**ADDENDUM
NO. 3**

June 9, 2023

**LAKE STREET ELEMENTARY SCHOOL ADDITIONS, RENOVATIONS,
AND RELATED WORK
Crown Point, IN 46307**

Addendum Three (AD.03) to the drawings and specifications prepared by Gibraltar Design for **Lake Street Elementary School Improvements** for Crown Point Community School Corporation, Crown Point, Indiana.

② TV OR PROJECTOR LOCAL OUTPUT
NTS

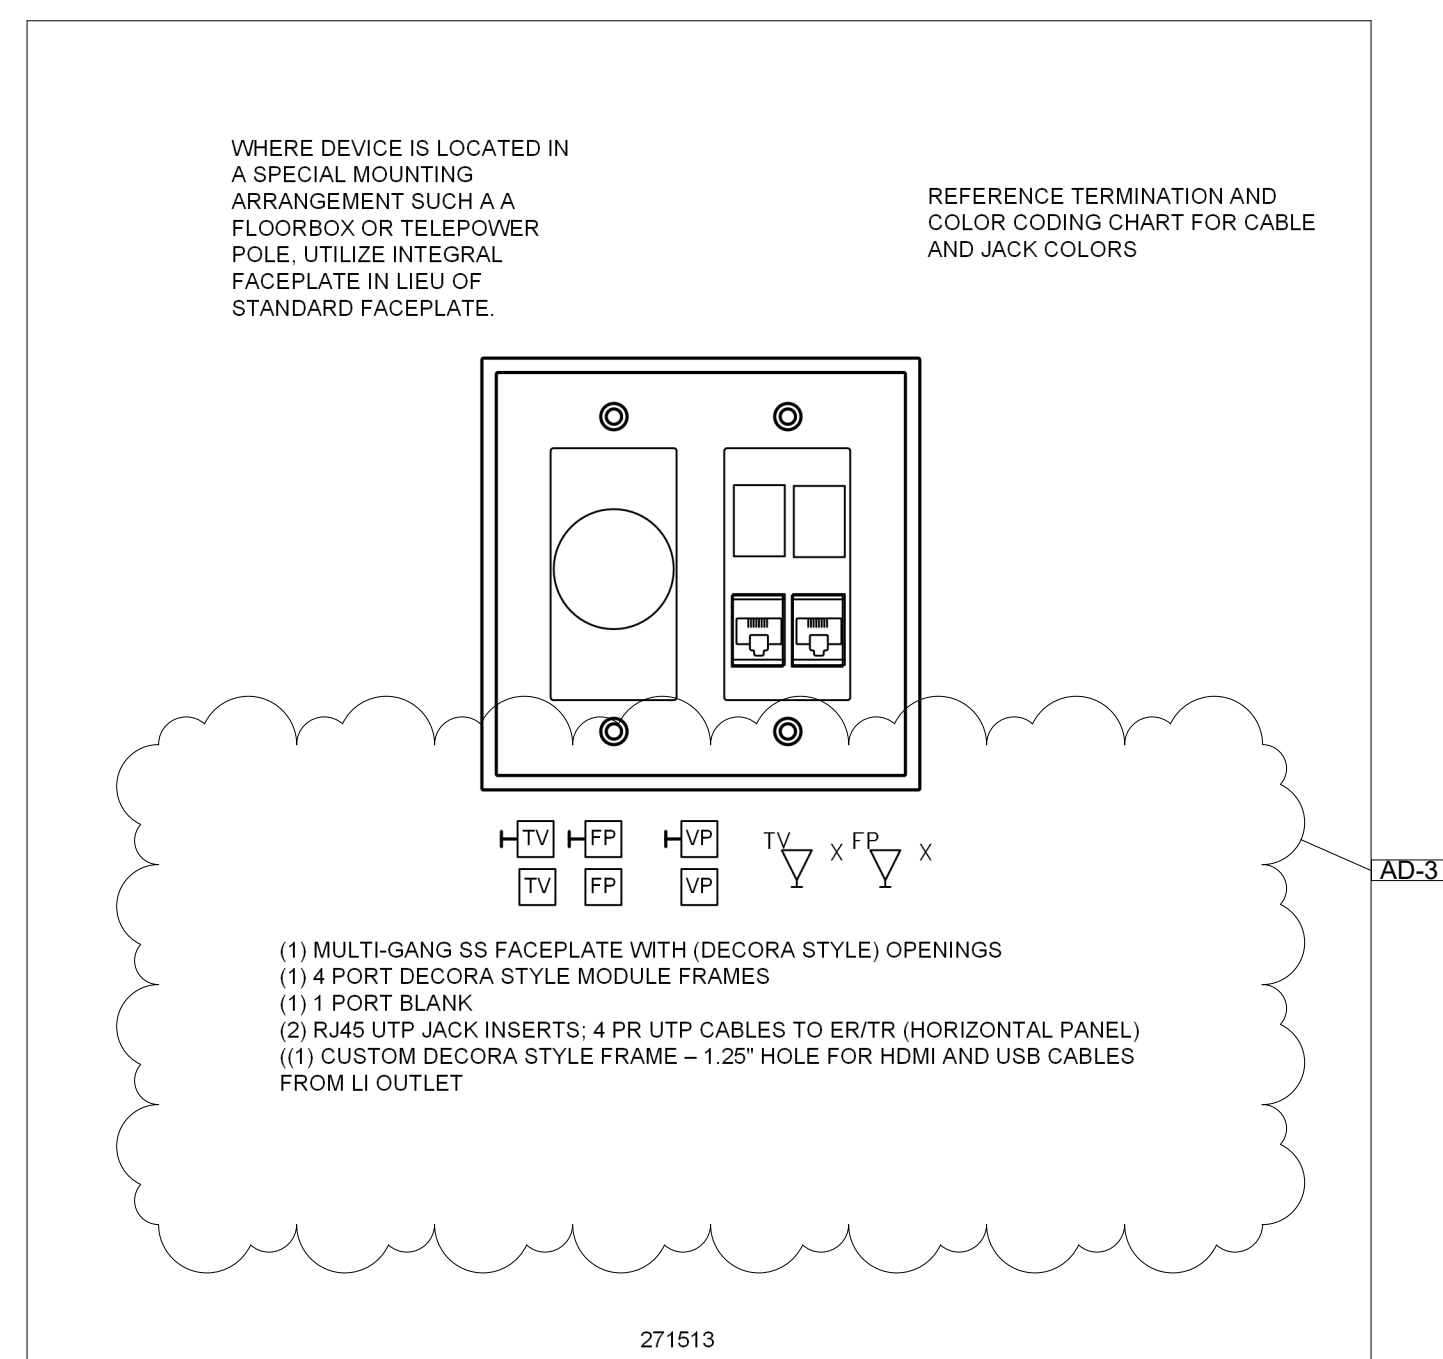
20. Sheet T-502

- A. Refer to revised, full-size drawing, included in this Addendum, for the following revisions:
 - 1. Updated detail 2 symbol references

6 TELEVISION MOUNTING AND ROUGH-IN
CLASSROOMS
NTS

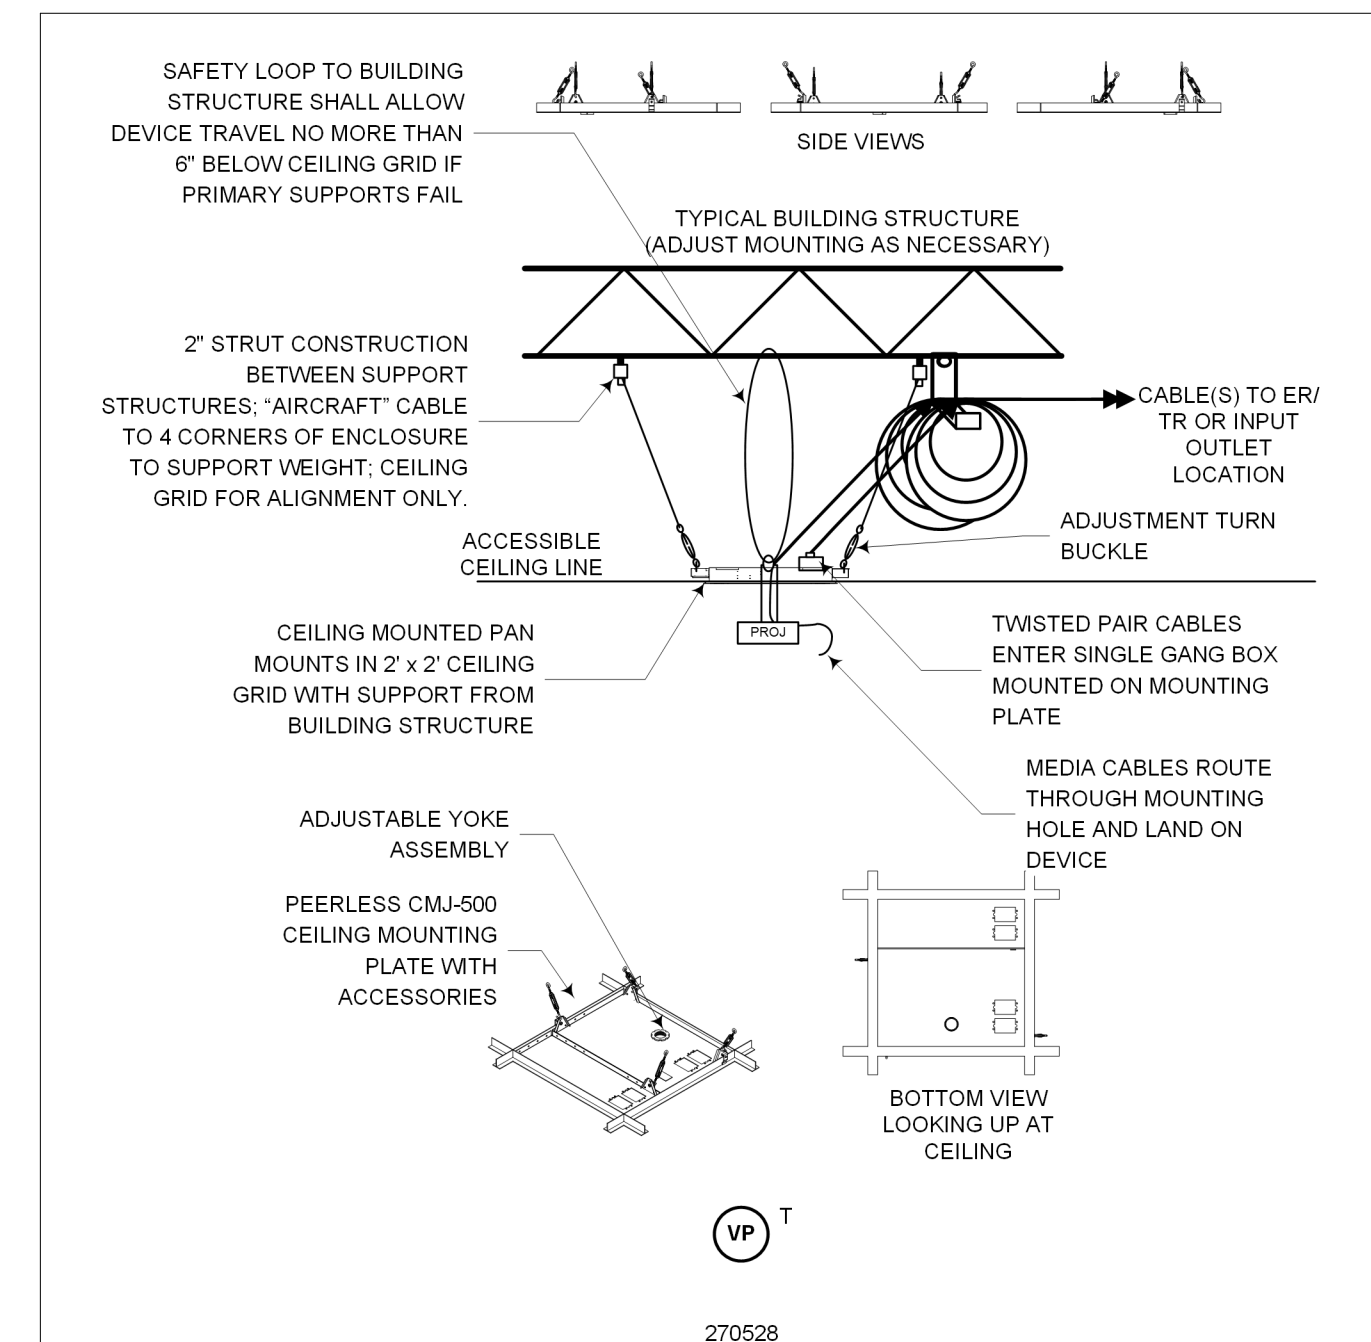
21. Sheet t-741

- A. Refer to revised, full-size drawing, included in this Addendum, for the following revisions:
 - 1. Replaced detail 6 for classroom TV outlets
